Site Accessibility Evaluation

Oxford Shed

**1910 Lower Old Hwy 6 Rd
NW
Oxford, IA 52322**

***Inspection Date: 04/24/2019
Inspector: Shelley Zuniga***

Finding: 2

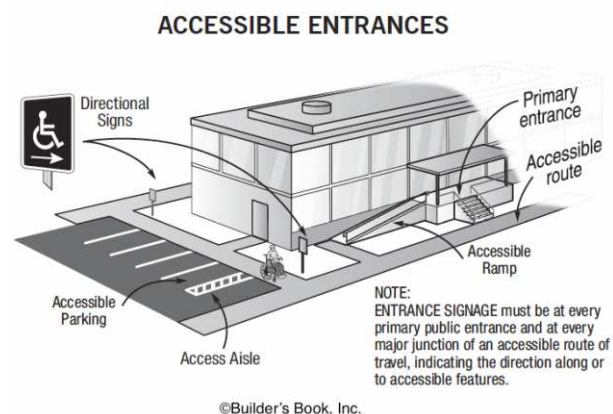
There is no accessible route between the buildings.

At least one accessible route shall connect accessible buildings, facilities, elements and spaces that are on the same site.

gravel route through
parking lot, 2" change
in level 2 main entry

Create AR with crushed and compacted stone or similar outdoor material from building to building within the site

Finding: 5

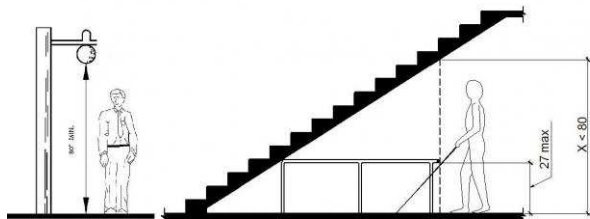
Multiple objects project more than 4 inches into the circulation path.

Wall-mounted objects that have leading edges between 27 inches and 80 inches from the floor must not project more than 4 inches into the circulation path. Protruding objects that extend to the floor or within 27 inches of the floor are cane detectable and are therefore not hazardous. Where it is necessary or desirable to have objects protrude from the wall, a manner of cane detection must be provided.

fire extinguisher in
bays 9", hose reel,
first aid 4"

For deficit, leave as is, employee work area pursuant to 2010 Standards 106.5 Defined Terms, until an employee with a disability works here

Finding: 6

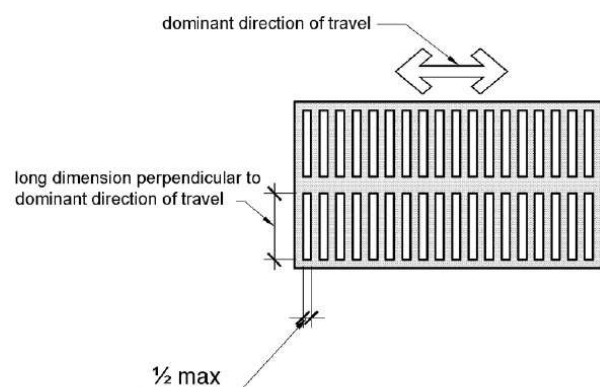
Gratings are spaced greater than a 1/2 inches in the direction of traffic flow.

Openings in floor or ground surfaces shall not allow passage of a sphere more than 1/2 inch diameter. Elongated openings shall be placed so that the long dimension is perpendicular to the dominant direction of travel.

1" in bays

Leave as is, grating, integral to the use of the site.

Finding: 7

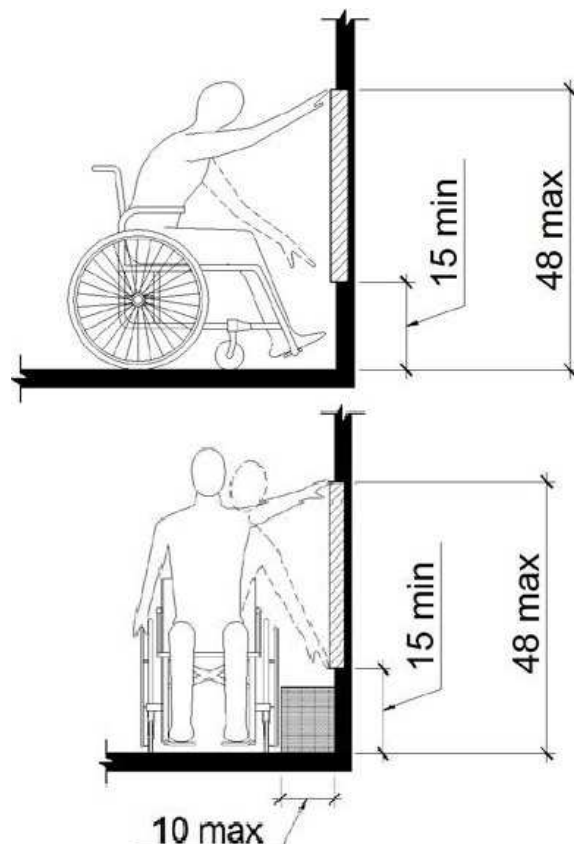
The thermostat and first aid is positioned too high for either a side or front approach.

Where a clear floor or ground space allows a parallel approach to an element and the side reach is unobstructed, the high side reach shall be 48 inches maximum and the low side reach shall be 15 inches minimum above the finish floor or ground.

Where a forward reach is unobstructed, the high forward reach shall be 48 inches maximum and the low forward reach shall be 15 inches minimum above the finish floor or ground.

thermostat in bays,
first aid

For deficit, leave as is, employee work area pursuant to 2010 Standards 106.5 Defined Terms, until an employee with a disability works here

Finding: 9

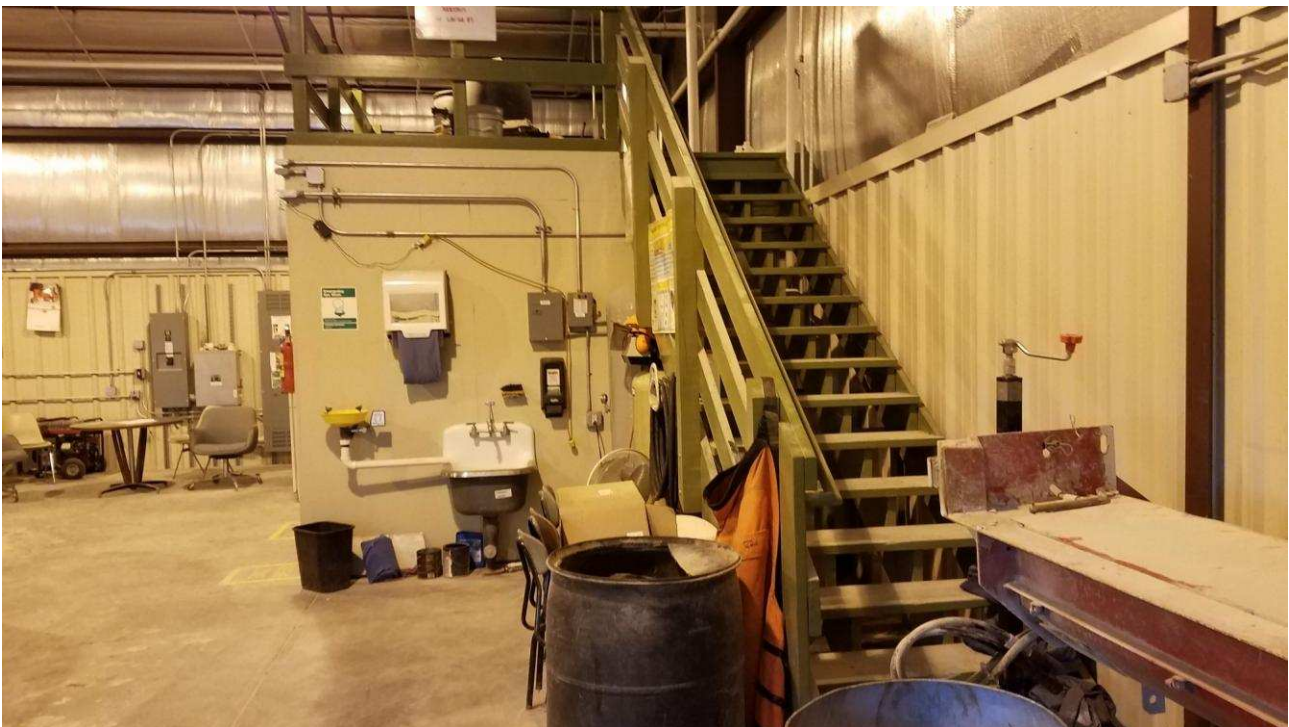
There is no accessible route between the main floor and the mezzanine

An accessible route of travel must connect all elements and spaces within a building or facility.

stairs to
loft/mezzanine

No AR to upper level employee area, leave as is, and reassign duties if an employee with disabilities requires access here

Finding: 10

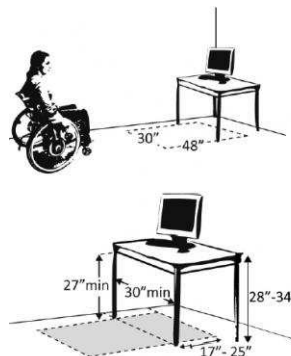
Compliant knee and toe clearance is not provided at the accessible table.

When seating for persons in wheelchairs is provided at fixed tables or counters, knee spaces at least 27 inches high, 30 inches wide and 19 inches deep shall be provided.

break area tables lack
knee clearance

Replace one of the tables with ones providing required knee and toe clearances

Finding: 11

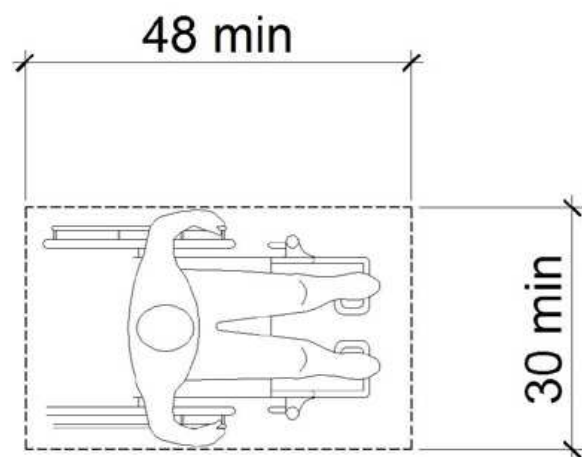
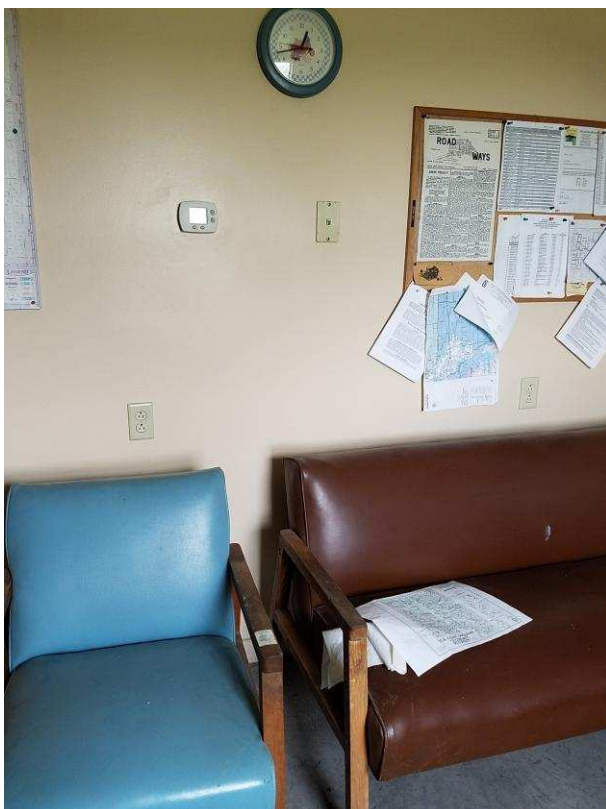
The operable part is not accessible because there is not adequate clear floor space for either a forward or side approach.

The clear floor or ground space shall be 30 inches minimum by 48 inches minimum.

thermostat and
outlets lack clear floor
space in office

For deficit, leave as is, employee work area pursuant to 2010 Standards 106.5 Defined Terms, until an employee with a disability works here

Finding: 12

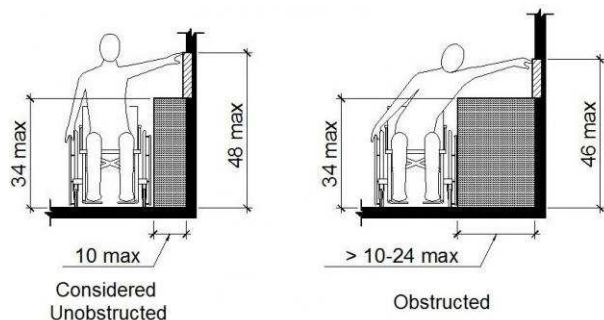
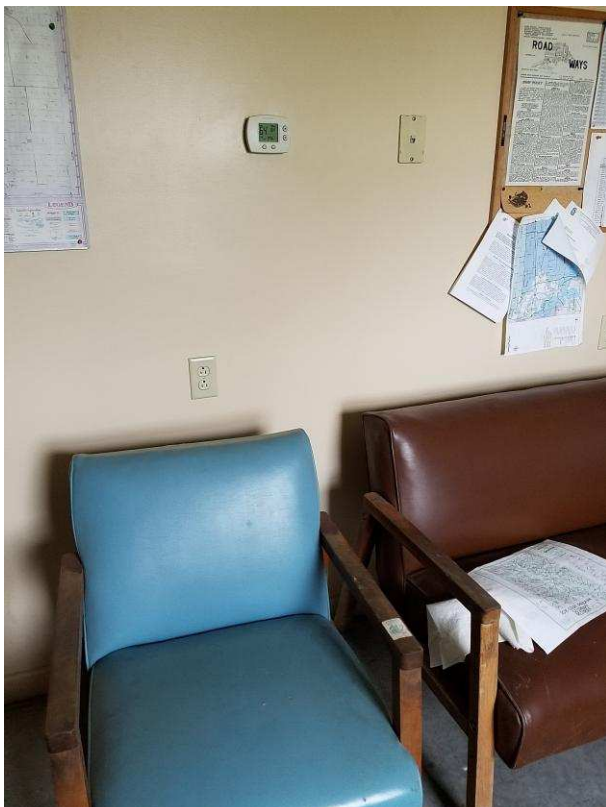
The operable part is too high and is out of the maximum reach range for a side approach.

Where a clear floor or ground space allows a parallel approach to an element and the high side reach is over an obstruction, the height of the obstruction shall be 34 inches maximum and the depth of the obstruction shall be 24 inches maximum. Where the reach depth exceeds 10 inches, the high side reach shall be 46 inches maximum.

thermostat too high
behind chair in office

For deficit, leave as is, employee work area pursuant to 2010 Standards 106.5 Defined Terms, until an employee with a disability works here

Finding: 14

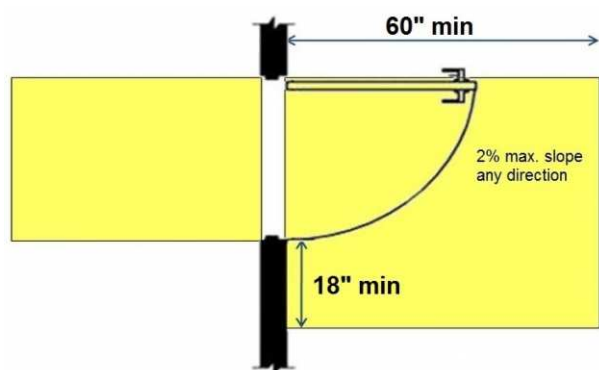
The maneuvering space on the pull side of the door does not adequately extend beyond the latch side of the door.

Maneuvering space for interior doors on the pull side with a front approach must be flat (2% max. slope in any direction) for a minimum distance of 60 inches in the direction of travel. The width of the maneuvering space must be as wide as the door plus an additional 18 inches on the latch side. This latch side clearance must also be flat (2% max. slope in any direction) and clear of obstructions.

restroom- wall and
sink pull side

For all doors along the public circulation route, provide required maneuvering clearance on push and pull side of doors

For all doors along the public circulation route, relocate storage, furniture, and other obstacles to create 60" maneuvering space around doors

Finding: 15

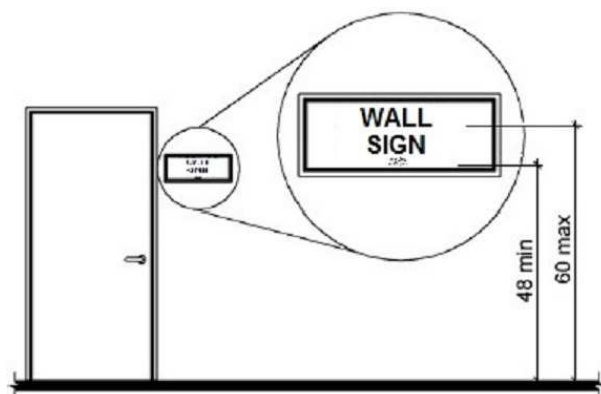
Compliant room identification signs are missing on the strike side of the door.

Wall signs identifying permanent rooms and spaces of a building shall be in a horizontal format and the characters raised 1/32 inch minimum and shall be sans serif uppercase characters a minimum of 5/8 inch and a maximum of 2 inches high. Contracted Grade 2 Braille shall be in a horizontal format and shall be placed a minimum of 3/8 inch and a maximum of 1/2 inch directly below the tactile characters; flush left or centered. Dots shall be 1/10 inch on center in each cell with 2/10-inch space between cells, measured from the second column of dots in the first cell to the first column of dots in the second cell. Dots shall be raised a minimum of 1/40 inch above the background. Braille dots shall be domed or rounded. Signs with raised characters or Braille shall be located 48 inches minimum above the finish floor or ground surface, measured from the baseline of the lowest tactile character and 60 inches maximum above the finish floor or ground surface, measured from the baseline of the highest tactile character.

restroom lacks
signage

Acquire and mount signage, including Braille and access symbol mounted on wall, latch side of door, 48" to baseline of lowest character and 60" to baseline of highest character

Finding: 16

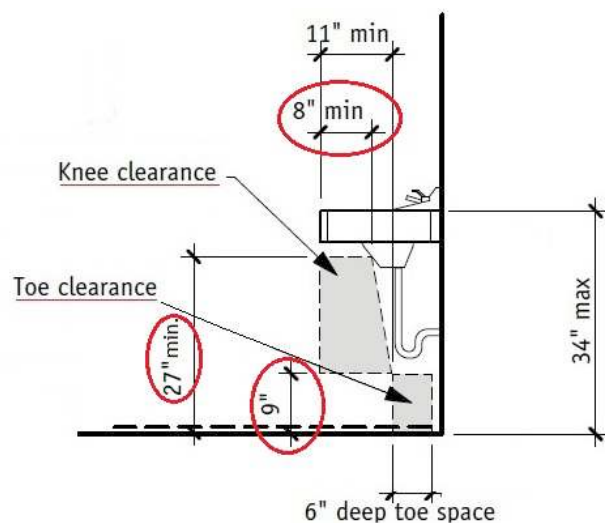
Knee clearance at 27 inches off the floor is not 8 inches minimum deep.

The knee clearance, measured from the bottom of the apron or the outside bottom edge of the lavatory, must be 27 inches at a point located 8 inches back from the front edge and continuing to 11 inches minimum in depth at 9 inches above the floor. The top of the lavatory rim may be no higher than 34 inches.

sink lacks depth for
knee clearance

Replace sink with one providing 27" knee clearance that is a min 8" deep

Finding: 17

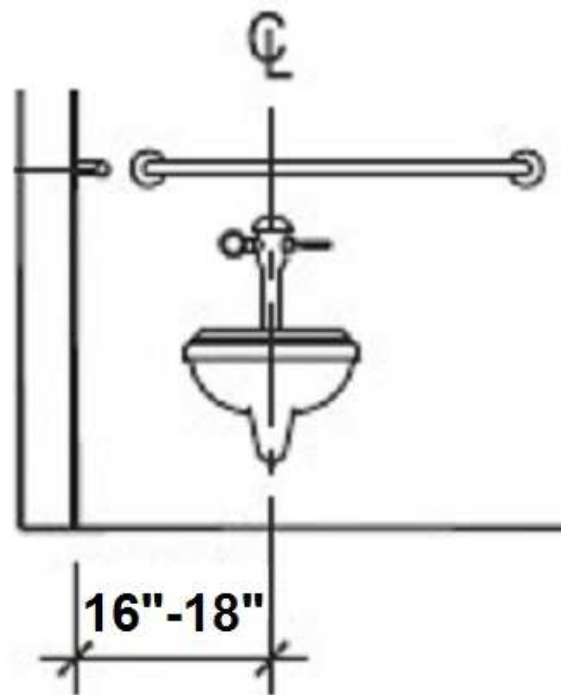
The toilet is not located within the range allowed from the side wall or partition.

The centerline of the toilet must be 16 to 18 inches from the side wall.

centerline 25.5"

Remount toilet to 16" to 18" from the side wall to centerline

Finding: 18

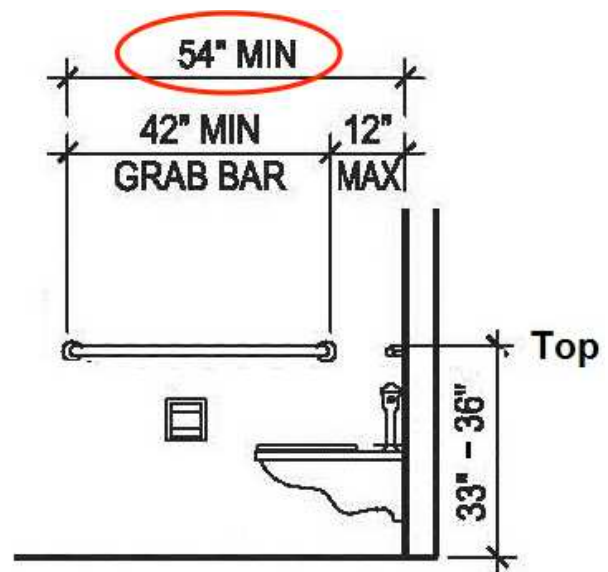
The side grab bar does not extend far enough from the rear wall.

The side grab bar must extend at least 54 inches minimum beyond the rear wall and start a maximum of 12 inches from the rear wall. A 42 inch grab bar installed the maximum distance from the rear wall (12 inches) will leave the leading end 54 inches from the rear wall. Grab bars shall be installed in a horizontal position, 33 inches minimum and 36 inches maximum above the finish floor measured to the top of the gripping surface.

side grab bar fails,
extends to 51"

Remount side grab bar to max 12" from the rear wall at the close end and min 54" on the far end, and 33" to 36" aff

Finding: 19

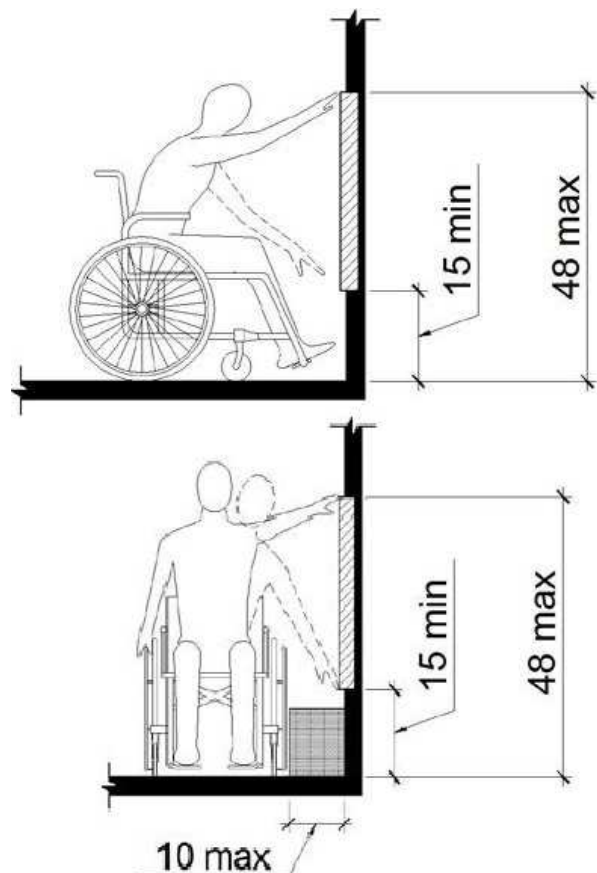
The hooks and paper towels are positioned too high for either a side or front approach.

Where a clear floor or ground space allows a parallel approach to an element and the side reach is unobstructed, the high side reach shall be 48 inches maximum and the low side reach shall be 15 inches minimum above the finish floor or ground.

Where a forward reach is unobstructed, the high forward reach shall be 48 inches maximum and the low forward reach shall be 15 inches minimum above the finish floor or ground.

hooks at 77.5" and
paper towels at 56"

Remount operable parts to be in reach range of 15" min to 48" max

Finding: 20

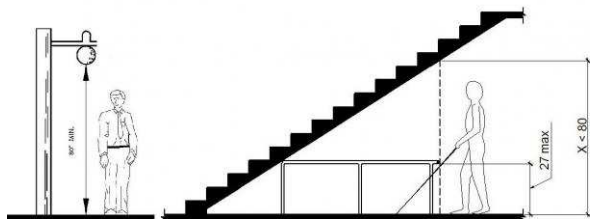
The cabinet projects more than 4 inches into the circulation path.

Wall-mounted objects that have leading edges between 27 inches and 80 inches from the floor must not project more than 4 inches into the circulation path. Protruding objects that extend to the floor or within 27 inches of the floor are cane detectable and are therefore not hazardous. Where it is necessary or desirable to have objects protrude from the wall, a manner of cane detection must be provided.

cabinet protrudes 13"
over the toilet

Relocate protruding objects or place cane detectable warning or bollard at foot of item
